Access Compliance Report Public Rights-of-Way (Curb Ramps)

Main Street: E_CENTER_ST Cross Street: HEWES_ST Location: NW

ADA ID: RPAT210929093125 Ramp Type: Type 4 - Parallel Initial Pass/Fail: Pass Overall Compliance: No Severity Score: 6

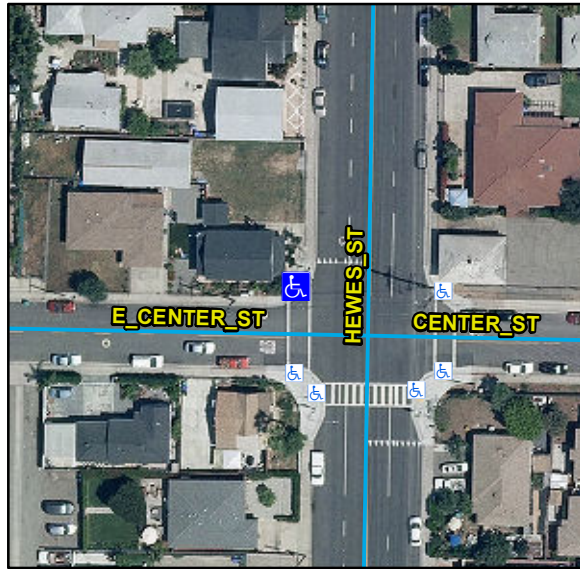
R304.2.2, R304.5.3, R304.5.4, STD 1115

Remove & Replace Curb Ramp With Two New Directional Ramps or Equivalent. Remove & Replace Gutter.
